ATLASSIAN CENTRAL DEVELOPMENT

SSD-10405 RESPONSE TO SUBMISSIONS & SUPPLEMENTARY DESIGN REPORT

30/06/21

FIGURE 1 - NORTH ELEVATION SOLAR SHADING STUDY - SUMMER SOLSTICE MORNING

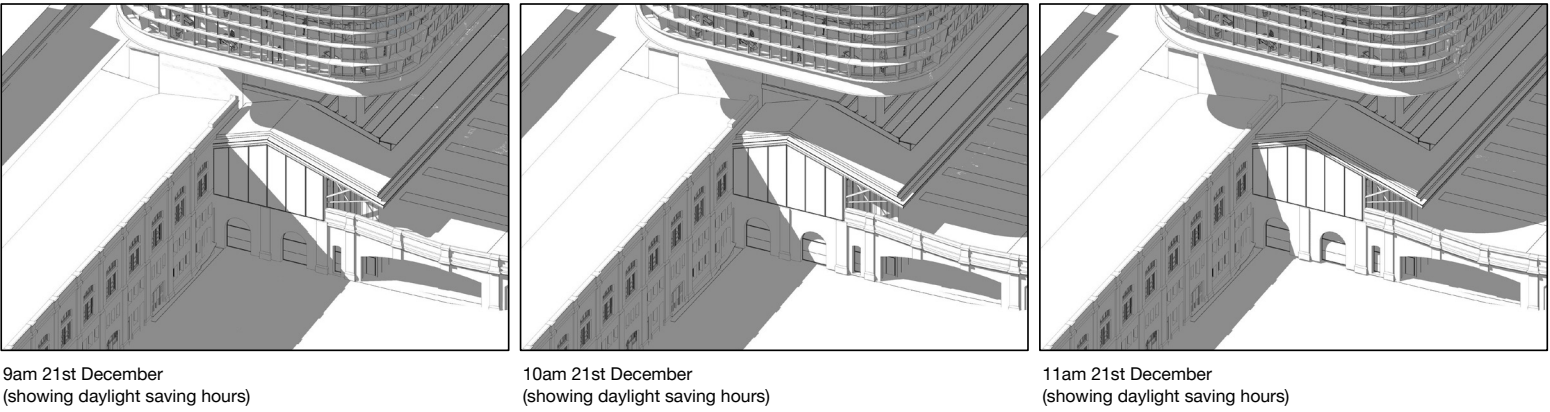
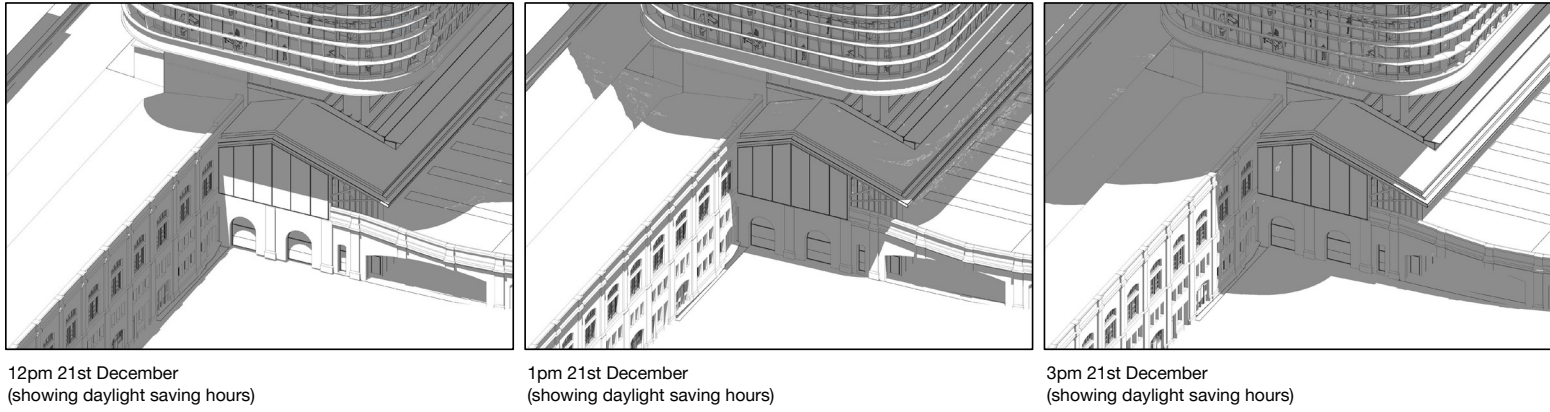
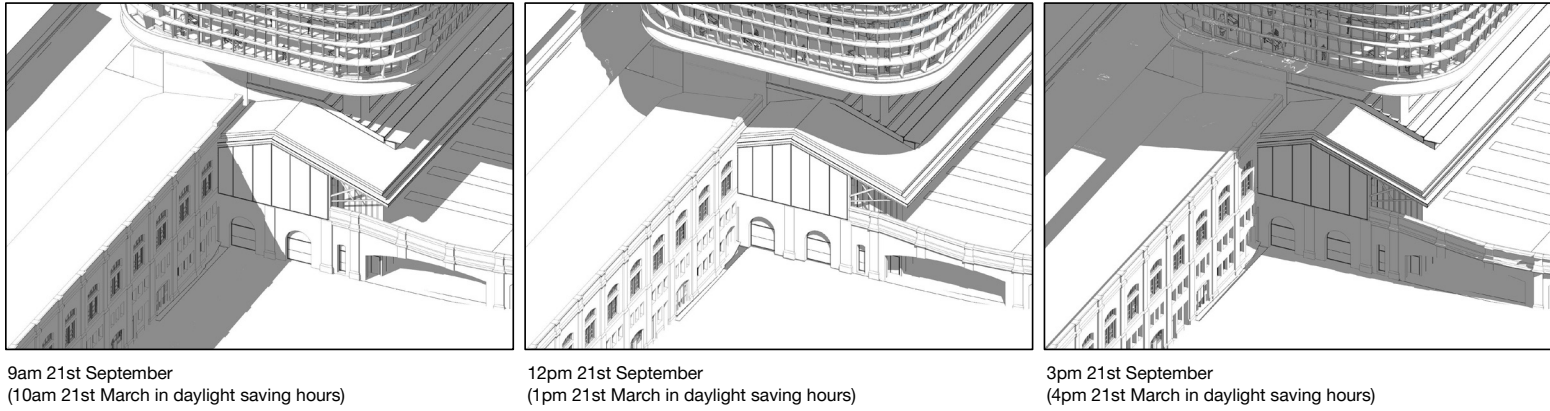
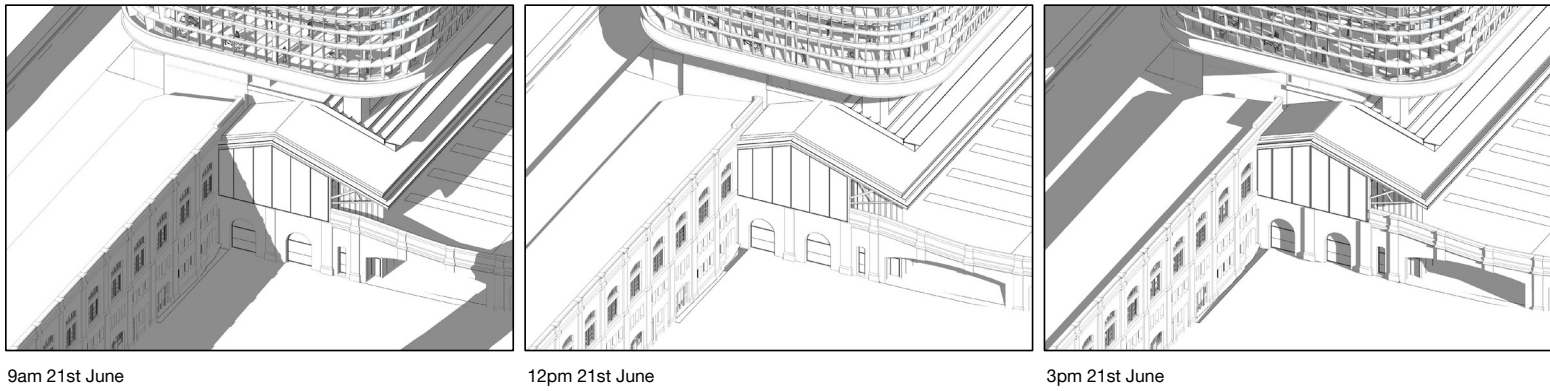
City of Sydney Comments	Response
The visual impact of the large glass cladding of the shed on northern elevation is uncharacteristic, somewhat bland and looks unfinished. In addition, considering the north orientation, it will negatively impact on energy performance. A preferable solution may be to undertake an interpretative re-construction. The original windows could be refurbished and returned to their original locations in the elevations. The areas of (formerly solid weatherboard) walls surrounding them may be glazed but clad with build external timber horizontal louvres based on the proportions and materiality of the original weatherboard cladding. This can deliver an appropriate level of passive sun control and present a more solid appearance more consistent with the original building. This would allow clear glazing and so would allow very good visual connection between the interior and exterior in all lighting conditions.	Refer 1.1.7 CoS Comment

The shadow diagrams in figures 1 to 4 show the extent of shadows to the North facade during the Winter and Summer solstices and the Equinox.

As the space is natural ventilated and open to the outside ambient air temperature, sunshades and

FIGURE 1 - DAY 1 WITH ATLASSIAN TOWER BUILDING WITH EXISTING BUILDINGS TO ADJOINING SITES. IMAGE BY RDWI

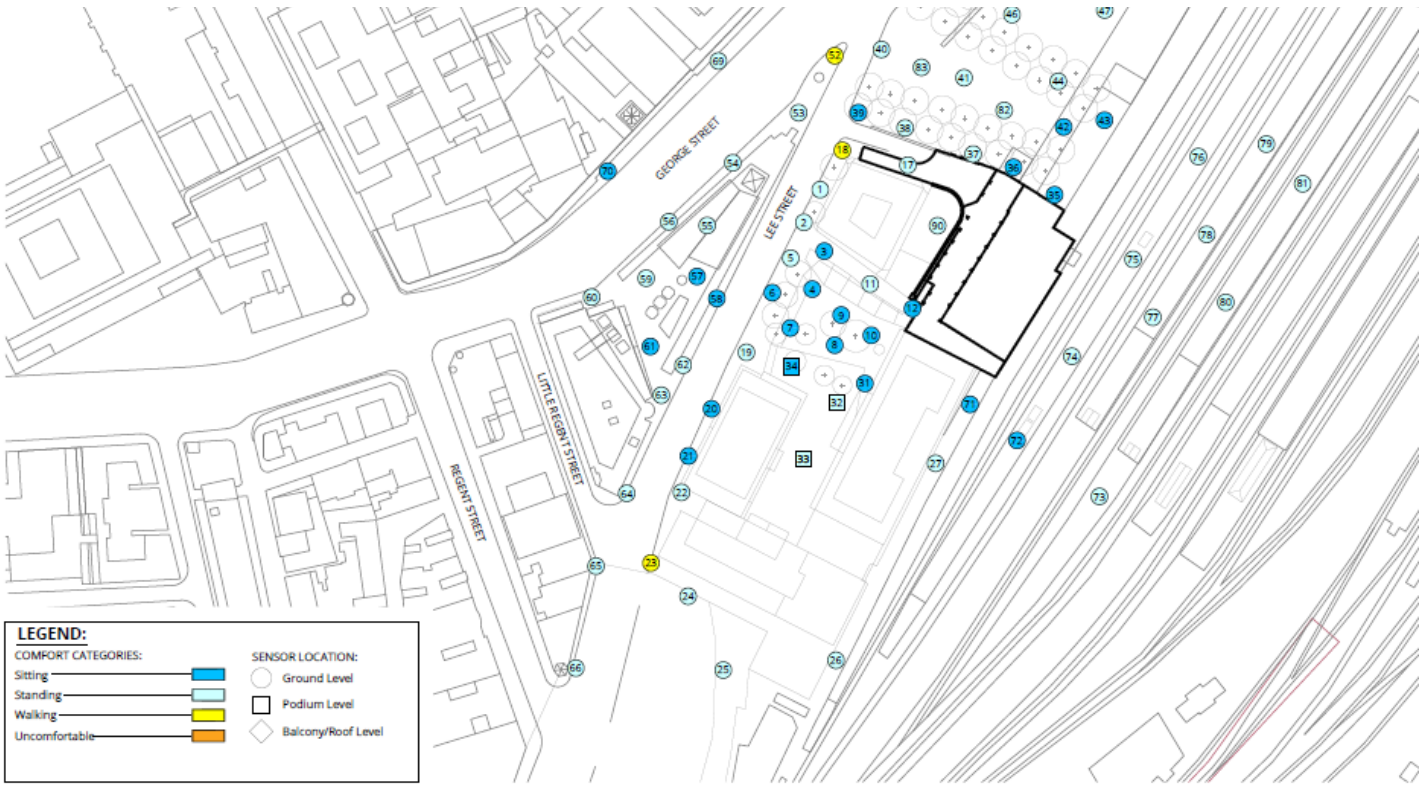
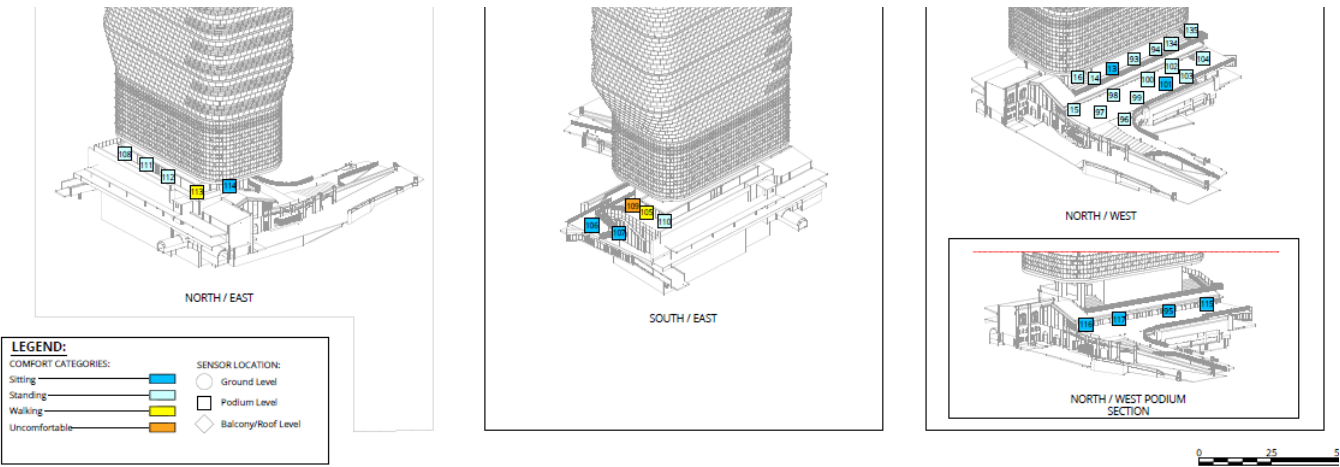
Wind Impacts	
One location (23) is disregarded as it is a function of the existing context. Under the Atlassian + Dexus/Frasers development scenario, the safety standard is exceeded at 14 locations. Under the Atlassian + Dexus/Frasers + Toga development scenario, the safety standard is exceeded at 13 locations. In all scenarios, a number of the safety exceedances occur on the ‘bleachers’, and in the Atlassian only scenario, additional exceedance occurs at the Upper Ground Level Plan, where outdoor sitting areas are planned. The proposal clearly does not comply with the Design Guidelines objectives for Wind in part 3.1.5, which are: Development within the sub-precinct must ensure that the cumulative impact of development on the wind environment does not result in uncomfortable or unsafe wind conditions on public domain within and surrounding the development taking into consideration the intended primary purpose of that space. The wind environment must be suitable for the intended uses.	Refer 1.1.8 CoS Comment

1.1.8 COS COMMENT: WIND MITIGATION TO OSD & PUBLIC DOMAIN

The result show that in day 1 when the Atlassian Tower is built and the adjoining developments have not, that all tested spots meet either walking, seating or walking comfort or safety criteria. See figure 1 &2. One location to the south-west corner of the OSD which just exceeds comfort conditions. A local temporary mitigation will be provided to ensure this point is safe in day 1.

Atlassian will do further work with the adjoining land owners to confirm the pubic domain meets wind comfort and safety requirements in all scenarios.

FIGURE 1 - DAY 2 WITH ATLIASSIAN TOWER BUILDING, D-F AND TOGA DEVELOPMENTS COMPLETED. IMAGE BY RDWI

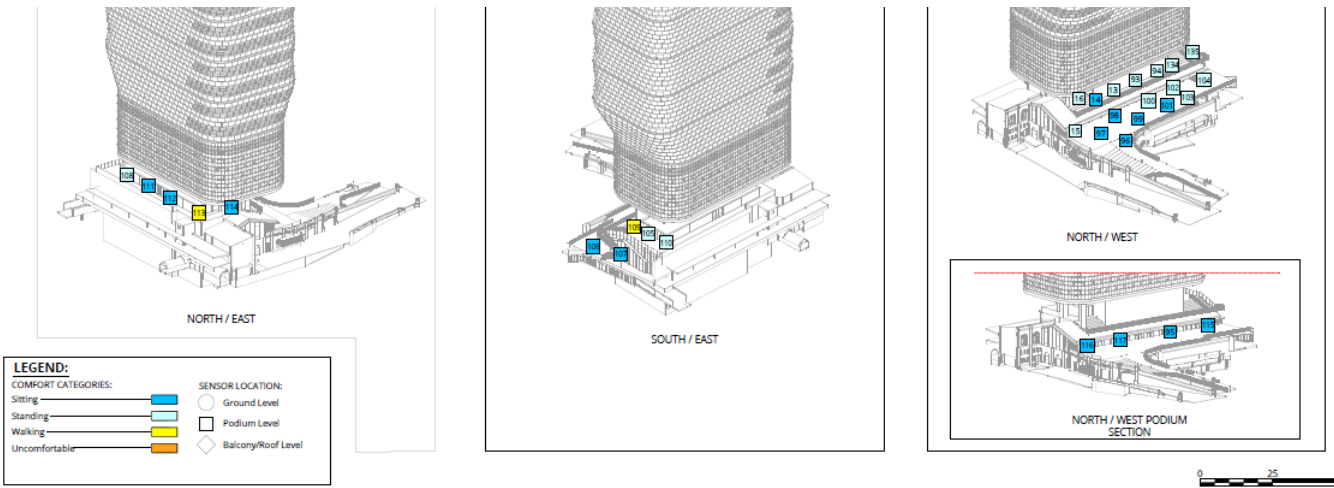
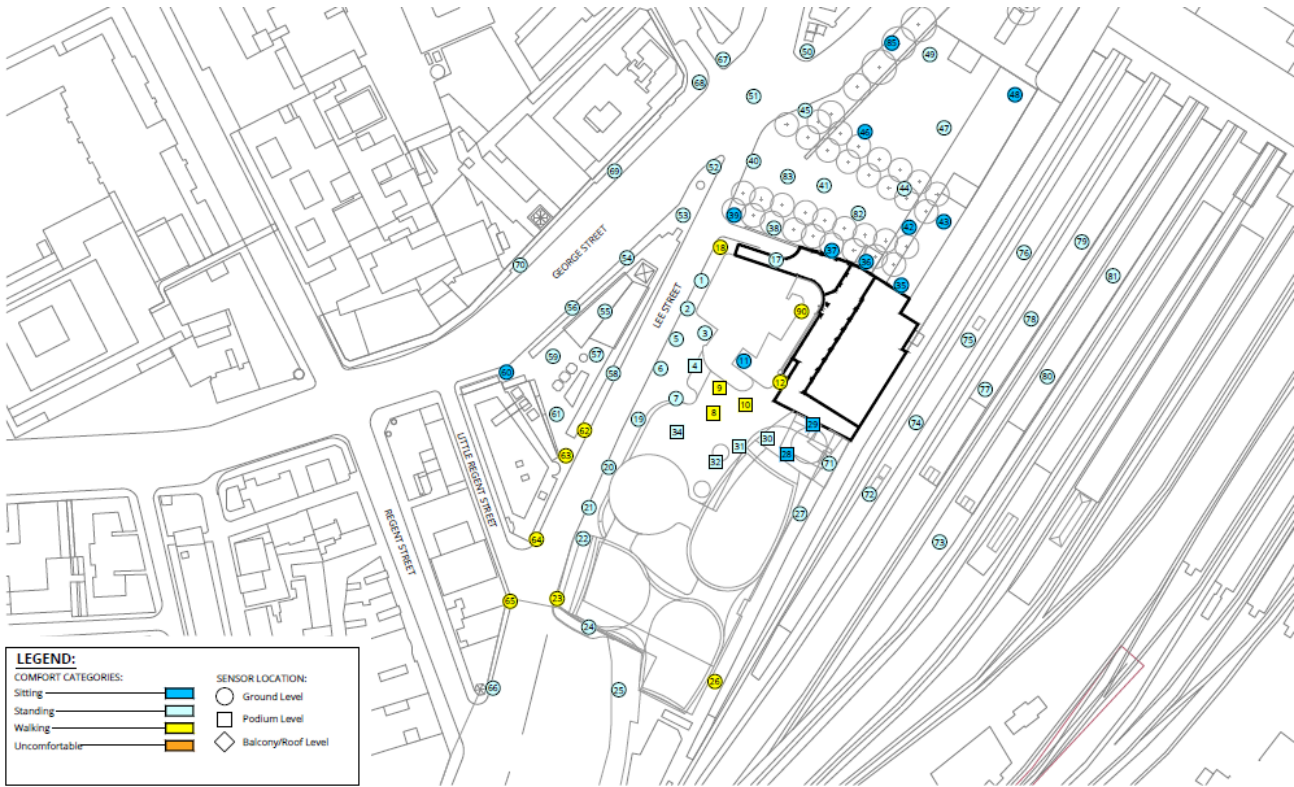
1.1.9 COS COMMENT:
WIND MITIGATION TO OSD
& PUBLIC DOMAIN

A precinct wide collaborative approach to Wind design and pedestrian comfort is ongoing as the adjoining developers progress their designs. We note that the Central Station OSD is still to be defined and will also have impact on the Western Gateway Sub-precinct and its public domain. Wind is a long term issue, and we would welcome a Department-led independent precinct wide wind tunnel testing approach.

FIGURE 1 - INDICATIVE TECHNICAL SECTION - LEVEL 15

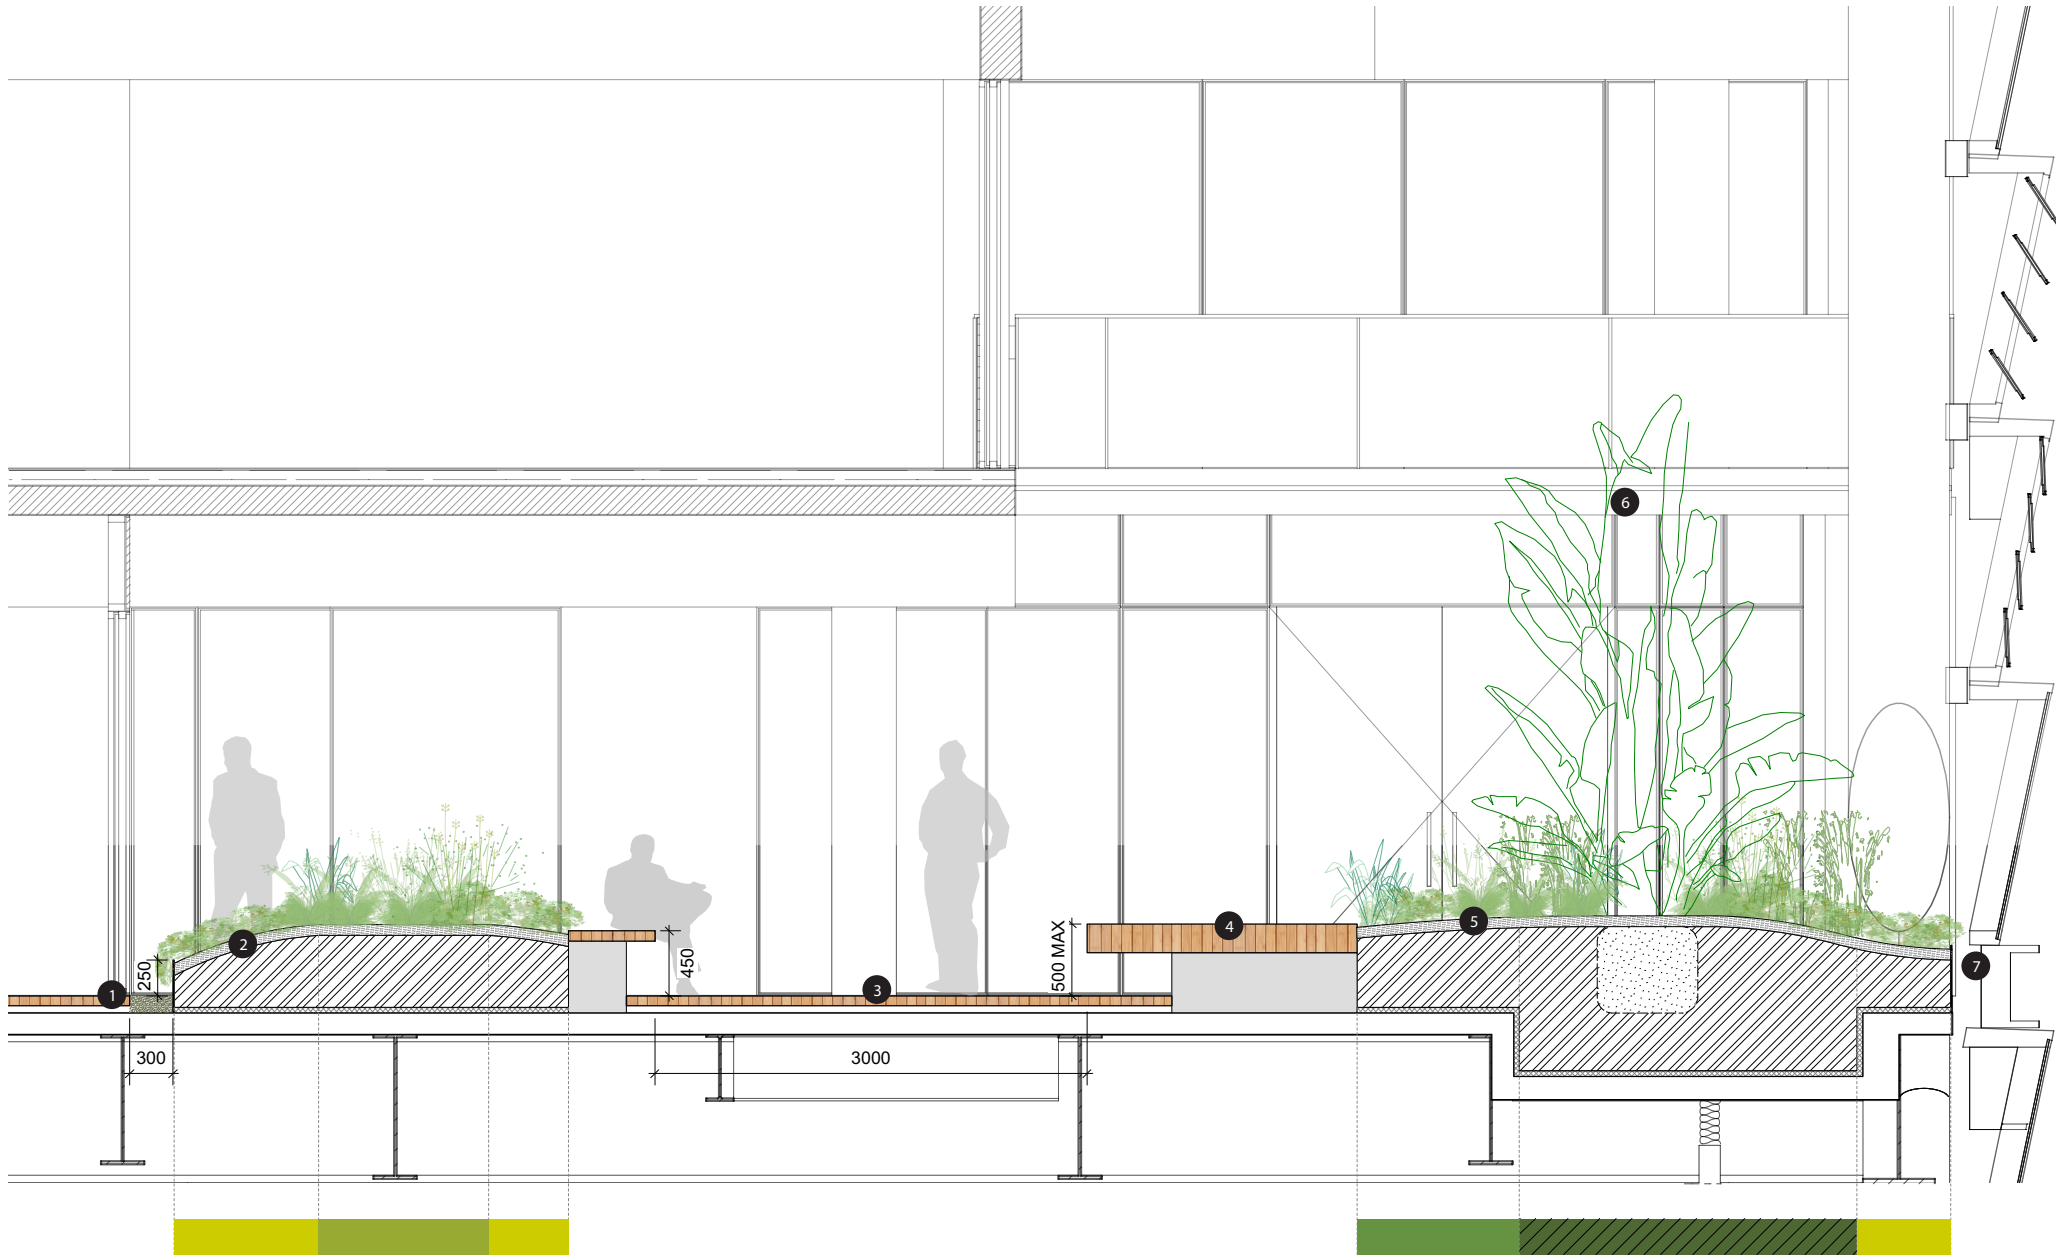
City of Sydney Comments	Response
Elsewhere on all habitat levels there are planters 500mm depth and free-standing narrow planters with shrubs located between seating areas and pods. Planters on level 7 and 11 will reflect typical L15 layout with planters set above ground with no slab downturns. 	Refer 1.1.20 CoS Comment
At the mid tower levels “Discover” Habitat on Levels 23,27,31 the planting theme is sensory planting theme with bushland species. Typical plan and section for Level 23 (Fig 9) through western edge of façade includes gum trees.	Refer 1.1.21 CoS Comment
The applicant also includes a caveat lower and mid-level landscape plans noting the “planting layout is indicative and subject to coordination with structural design and set downs”. This provides the consent authority no assurance the proposed landscaping is feasible.	Designs for habitat levels are expressed via typical layouts based on typical structural layouts applied to all floors. In the next phase of design, these will be coordinated on a floor by floor basis.

1.1.20 COS COMMENT: HABITAT PLANTER DEPTHS

- SOIL DEPTH 300-500MM
- SOIL DEPTH 500-600MM
- SOIL DEPTH 600-800MM
- SOIL DEPTH 800-1000MM (WITHIN STRENGTHENED ZONE OF FLOORPLATE)
